**25 W MAIN ST DEVELOPMENT
ADDENDUM 1 EXHIBIT**

E & W MAIN, S CARROLL, S PINCKNEY 2017
PROJECT NO. 11429 SHEET NO.
W-5

WATER PLAN AND PROFILE

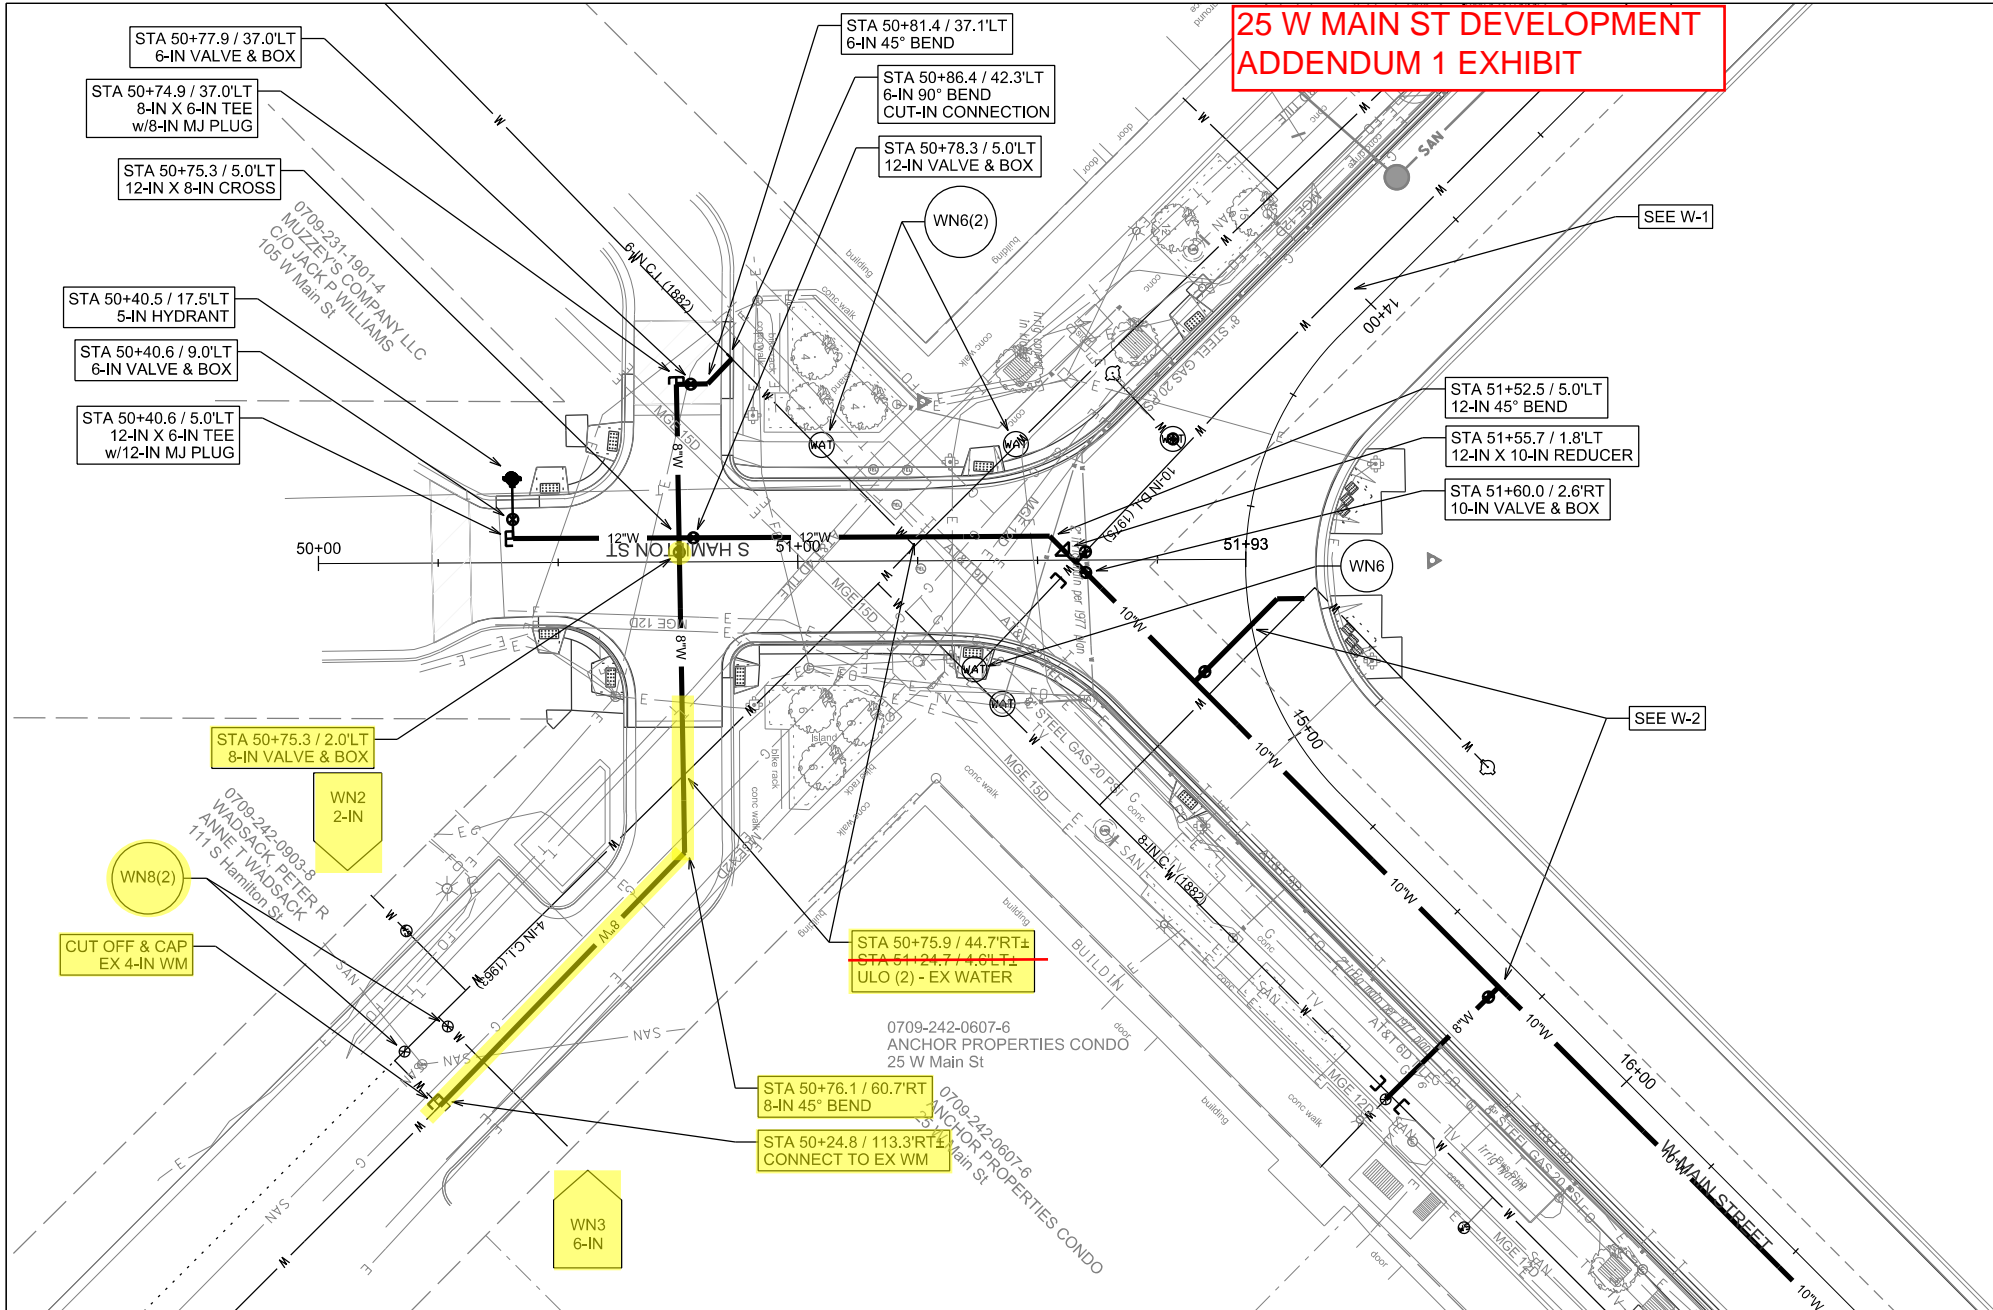
**Approx. related work to
25 W Main development**
